***Adaptive Reuse of the Clare Hotel and
Administration Building on Block 3A***

***Central Park, Chippendale
(Former Carlton United Brewery)
MP11_0089***

Director-General's
Environmental Assessment Report
Section 75I of the
Environmental Planning and Assessment Act 1979

April 2013

Figure 2 - East Elevation with increased setback above the Clare Hotel (source: Proponent's RtS)

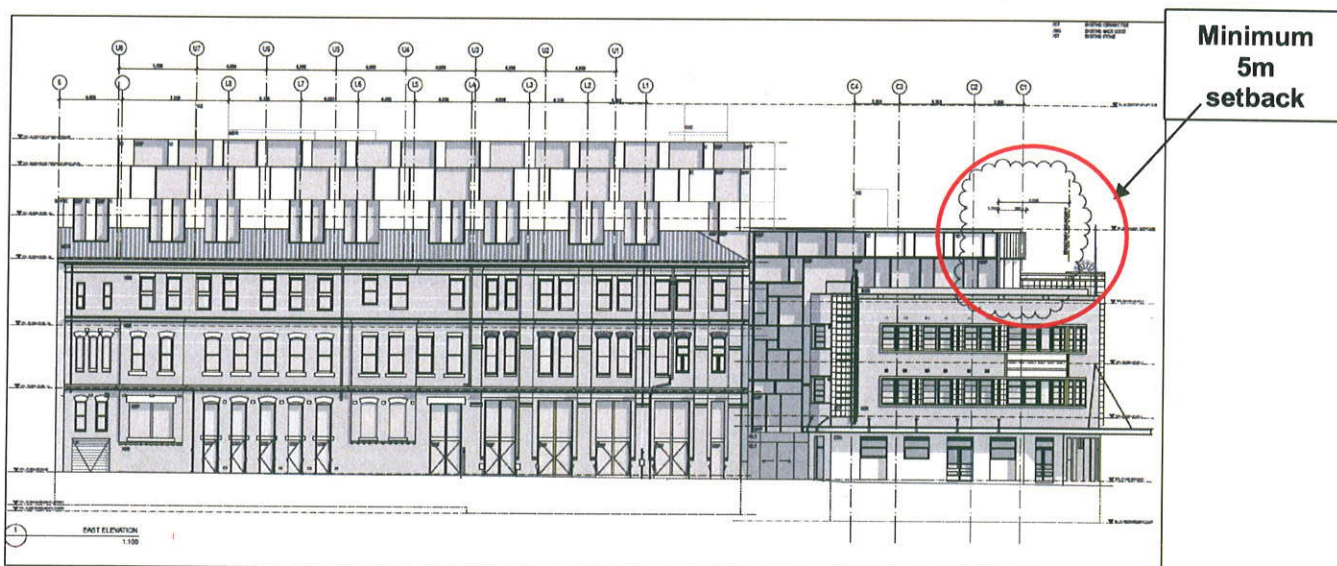
- Generally considers that height breaches to the Concept Plan acceptable subject to further detail demonstrating the proposal would not have adverse impacts when viewed from Carlton Street;
- Recommends the additional floor above the Clare Hotel be set back a minimum of 5 metres from the northern boundary of the site;
- Noted that there is no capacity to conserve the executive passenger lift and enclosure in the design and construction methodology;
- Recommends adequate recording of significant interior spaces prior to dismantling the passenger lift and enclosure and that a protection and construction methodology be developed and submitted to Council; and
- The link between the Clare Hotel and Administration Building is not consistent with the Concept Plan approval however is considered generally acceptable.

On 22 February 2013, the Department wrote to the Proponent outlining a number of key issues, requesting additional information and a response to all submissions received. On 5 March, 2013 the Proponent provided a response to the issues raised in submissions and issues raised by the Department (see **Appendix B**). The RtS made modifications to the Project including the provision of a minimum 5 metre setback to the addition on the north elevation of the Clare Hotel.

In the Proponent's RtS, the design was modified to incorporate the requested minimum 5 metre setback for the single storey addition. On this basis, the Department is satisfied that the proposal would protect and preserve existing significant features and supports the adaptive reuse of the Clare Hotel. In addition the Department considers that the Project is appropriate in terms of visual bulk, particularly given the increased setback above the Clare Hotel.

Figure 3 - Section through the Administration Building showing approved height in red

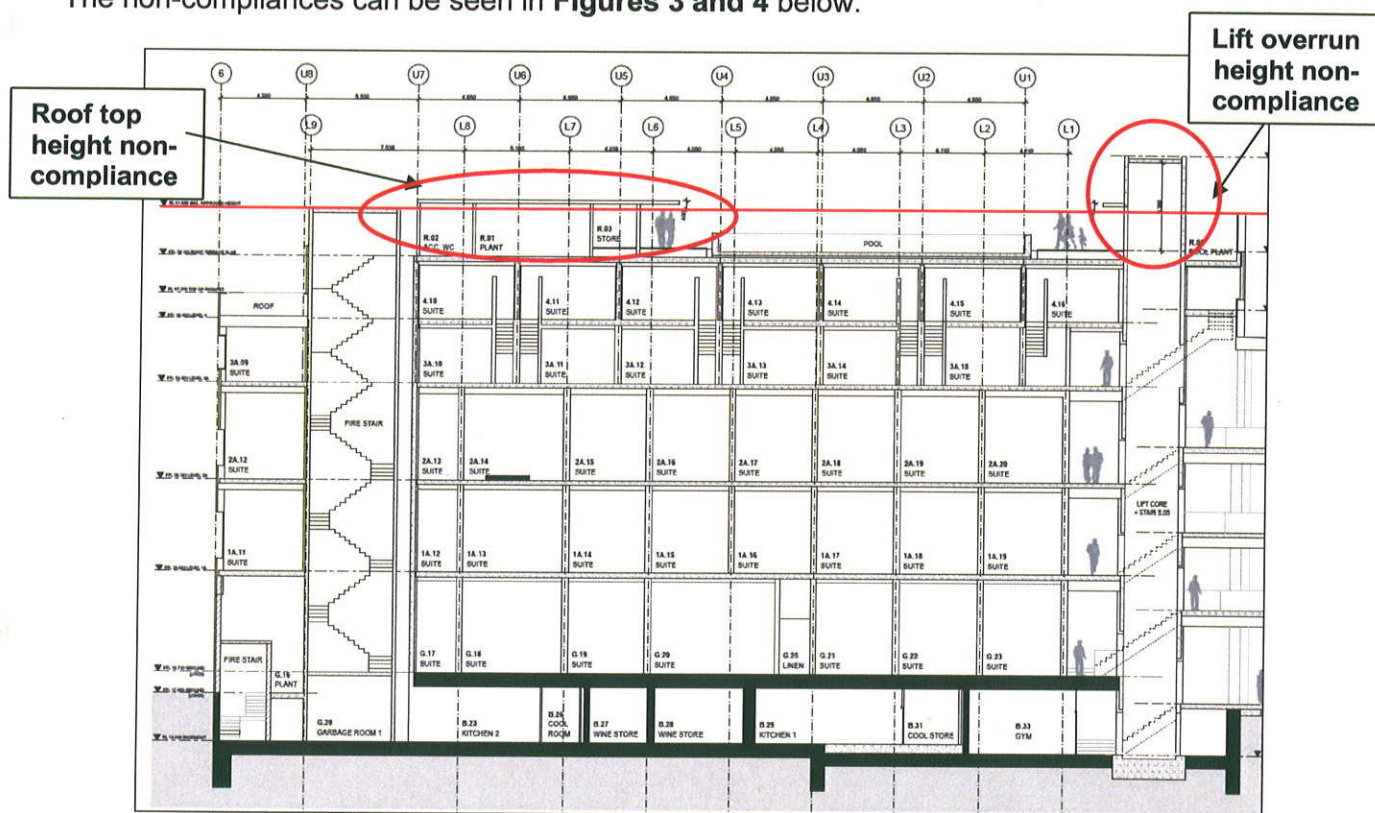
There are two elements of the proposed building that would not comply with the overall building height approved in the Concept Plan. These are:

1. the lift overrun; and
2. the roof top over the WC, plant room and pool side bar.

The non-compliance caused by the proposed lift overrun would project 2.7m above the maximum RL approved by the Concept Plan. This non-compliance is required to accommodate equitable access to the roof level. Only one lift would provide access to roof level and it is set back from the edge of the approved envelope to mitigate visual impact from the public domain.

The rooftop over the accessible WC, the plant area and the poolside bar, projects 400mm higher than the maximum building height approved by the Concept Plan. This minor non-compliance with the Concept Plan is to accommodate the heritage conservation measures required for the Heritage Boardroom Suite on Level 2, while retaining the minimum floor to ceiling heights on the floors above.

Figure 5 - Photomontages from Carlton Street illustrating visual impact of Concept Plan height breaches

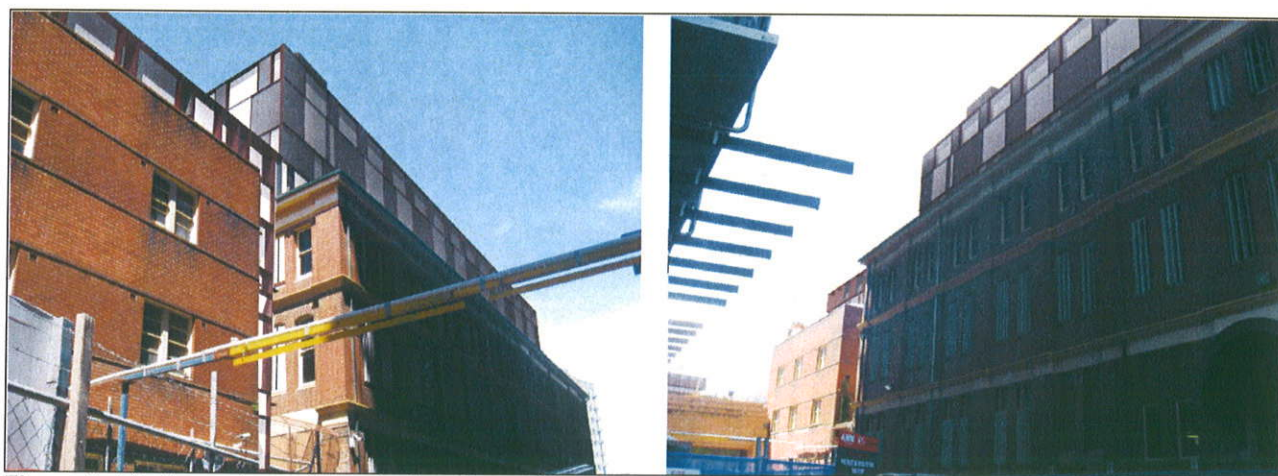
At the request of the Department, the Proponent submitted additional photomontages from Carlton Street (**Figure 5**). The photomontages demonstrate that the height of the non-complying rooftop features would only be marginally discernable from the surrounding public domain. Further, the non complying features would not significantly increase visual bulk or overshadowing. Overall the area of non-compliance is considered to be minor and would not significantly alter the appearance of the building. Accordingly, the proposed height is considered to be acceptable.

Figure 6 – Approved Concept Plan Public Domain Plan

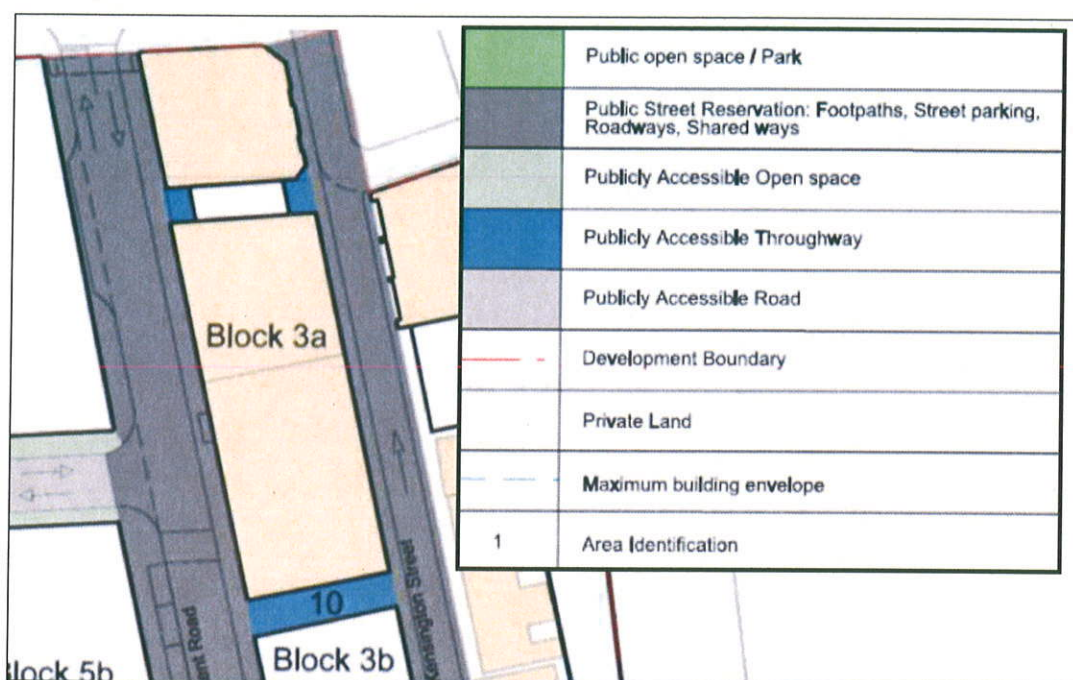
The proposal seeks to construct a through link entry lobby for the hotel between the existing Clare Hotel building and the Administration Building. This space has been identified as a publically accessible thoroughway in the approved Concept Plan, as illustrated in **Figure 6**. This link is intended to act as a ground floor lobby for the proposed boutique hotel. Although this space would be accessible by doors to both east and west sides, it is not designed as a public thoroughfare.

The link has been designed as a lightweight structure which would be predominantly transparent, being constructed of steel framed glazing (both clear and opaque). It is noted that Council has not raised any concerns with the location of the proposed link structure.
